S183106-MDL-01-1 Response to IPC on substation location

Re: 11 Gibbons Street, Redfern
Response to IPC on substation location

This letter is in response to a query from the Independent Planning Commission (IPC) on the location of the substation in relation to designated flood levels.

FIGURE A1
11 GIBBONS STREET, REDFERN
PEAK FLOOD DEPTH AND LEVEL CONTOUR
PROPOSED CASE - 1% AEP EVENT

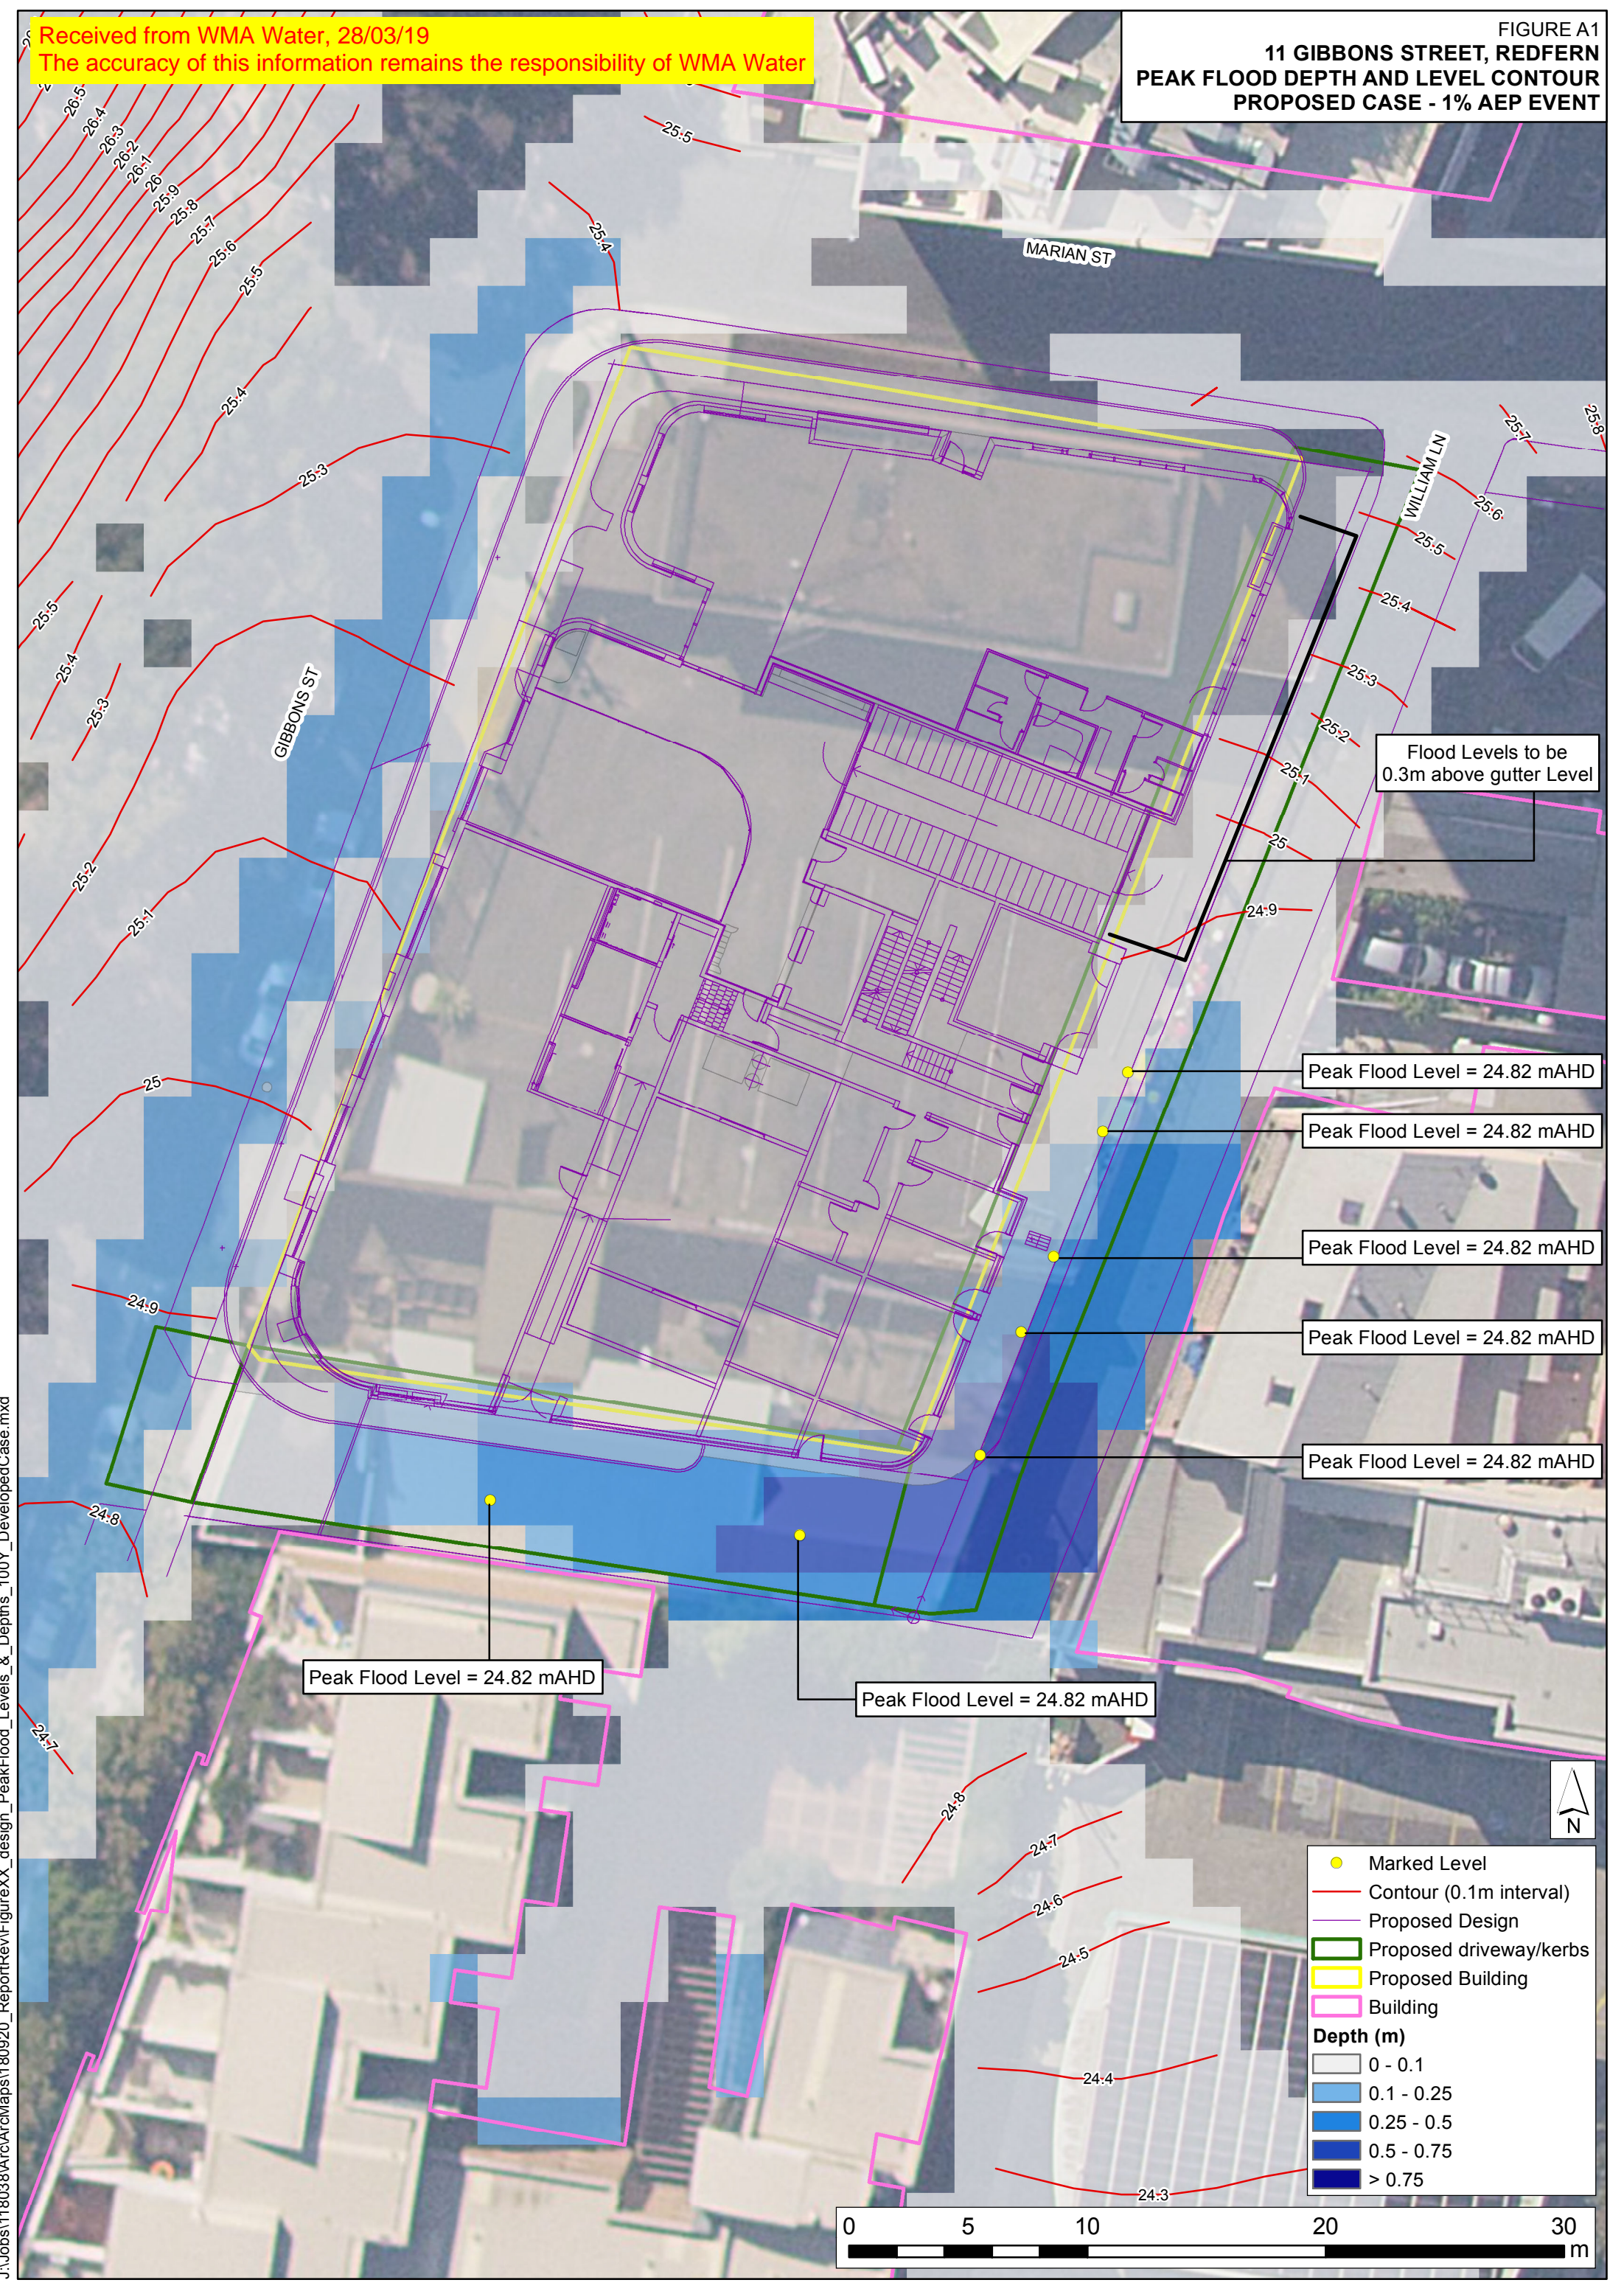
Confirmation from WMA water for 1% AEP flood levels on William Lane

To satisfy item 2, further detailed flood levels were sought from the flood modelling engineers WMA Water, who confirmed that the peak flood level along William Lane is RL 24.82. Refer to attached email correspondence and report from WMA water in Appendix A. The substation was then set at RL 24.83 to allow 10mm tolerance to this flood level.
